Date: February 5, 2009

Subject: S505 Product Change Notification

S505 Series, Time Delay, Ceramic Tube

Dimensions

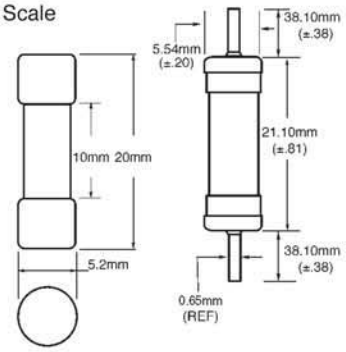
Fuse dimensions remain the same for all part numbers without axial leads. For fuses with axial leads (part numbers containing “-V”), some ratings will be fitted with larger diameter leads. Lead diameter for S505-V-4-R (all prefixes), and S505-V-5-R (all prefixes) has increased from 0.65mm to 0.81mm.

- Ratings above 6.3A have a 0.8mm diameter lead
- With TR2 packaging code, lead wire length is 19.05mm

TIME CURRENT CURVE

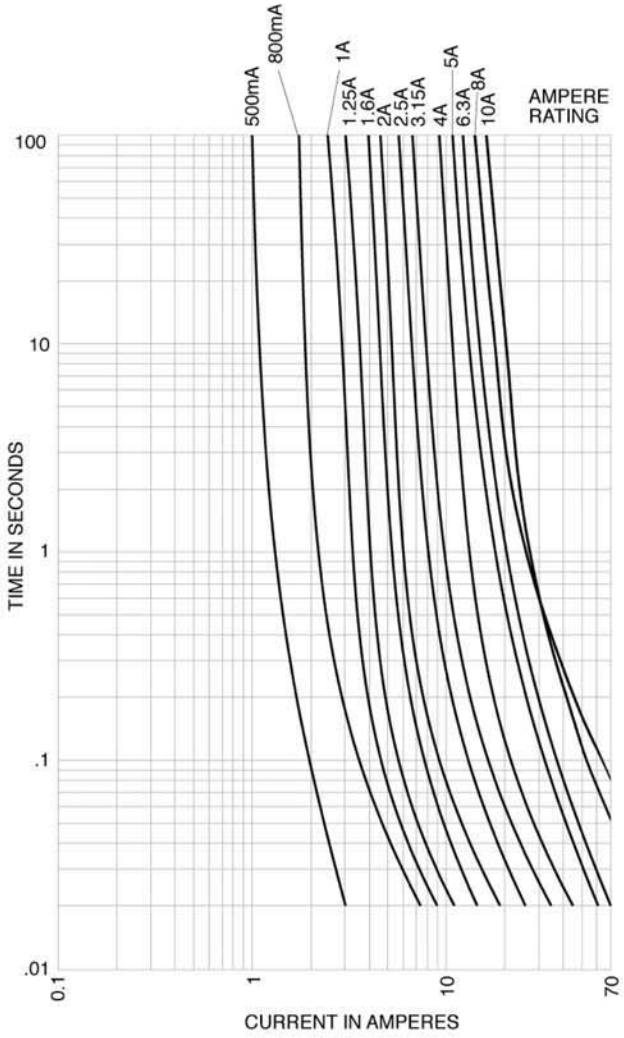
Over the next couple of months there will be a transition to the new design. There will be no changes to voltage ratings, interrupting ratings or max/min opening times. Changes in time-current characteristics are minimal. A new datasheet reflecting these changes is now available online at www.cooperbussmann.com/datasheets/elx.
